WELL API NO. 30-015-49263	
5. Indicate Type of Lease STATE <input type="checkbox"/> FEE <input type="checkbox"/>	
6. State Oil & Gas Lease No.	
7. Lease Name or Unit Agreement Name Swanson 3/2 B2OP Fed Com	
8. Well Number	1H
9. OGRID Number	14744
10. Pool name or Wildcat Sand Tank; Bone Spring	
4. Well Location Unit Letter <u>N</u> : <u>1200</u> feet from the <u>South</u> line and <u>2185</u> feet from the <u>West</u> line Section <u>3</u> Township <u>18S</u> Range <u>29E</u> NMPM County <u>Eddy</u>	
11. Elevation (Show whether DR, RKB, RT, GR, etc.) 3507' GL

WELL LOCATION AND ACREAGE DEDICATION PLAT

Operator: MEWBOURNE OIL CO P.O. Box 5270 Hobbs, NM 88241	OGRID: 14744
	Action Number: 175890
	Action Type: [C-103] NOI Change of Plans (C-103A)

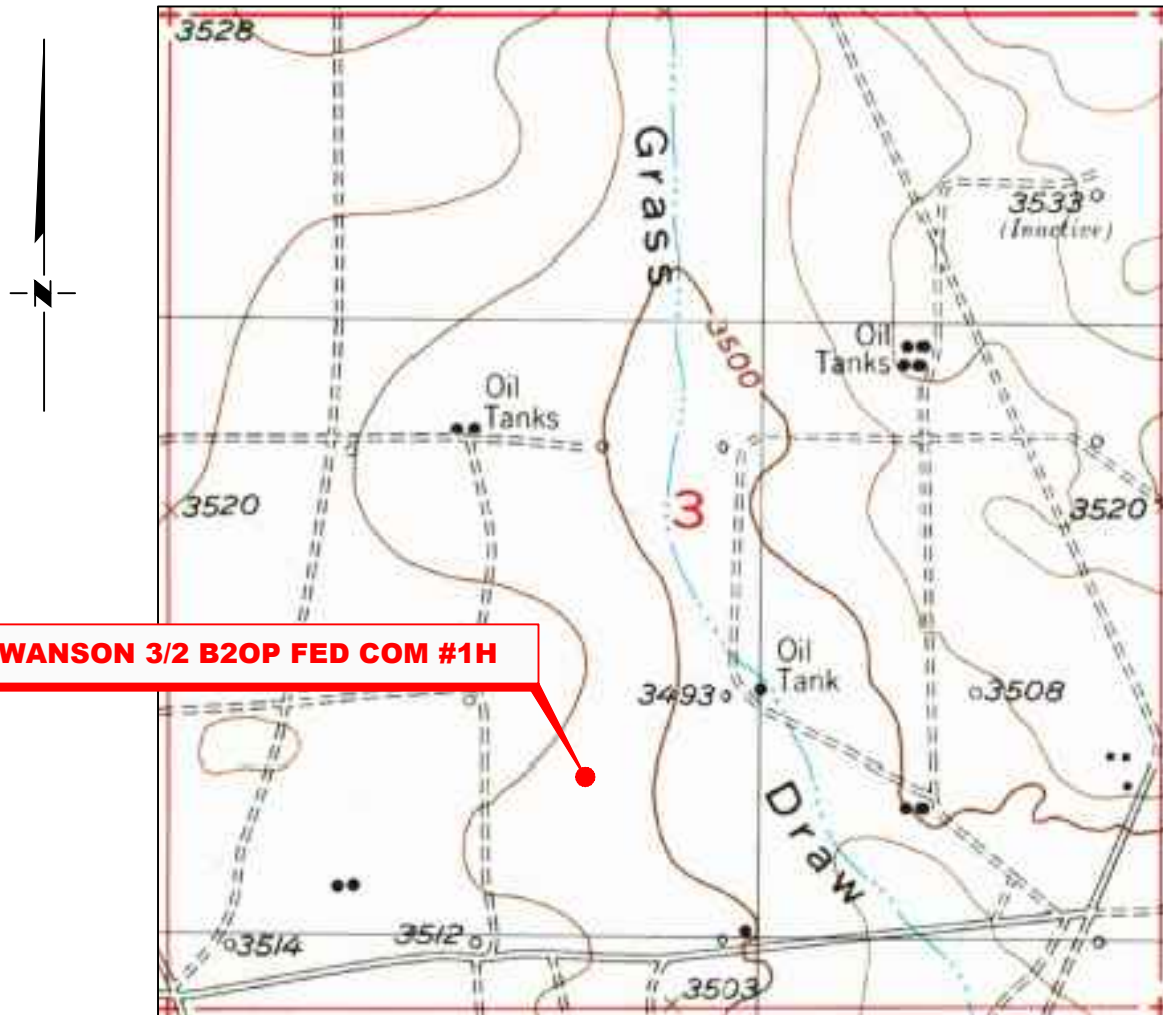
1) Change SHL from 1200' FSL & 2470' FEL to 1200' FSL & 2185' FWL, Sec 3, T18S, R29E

UL or lot no.	Section	Township	Range	Lot Idn	Feet from the	North/South line	Feet From the	East/West line	County
N	3	18S	29E		1200	SOUTH	2185	WEST	EDDY
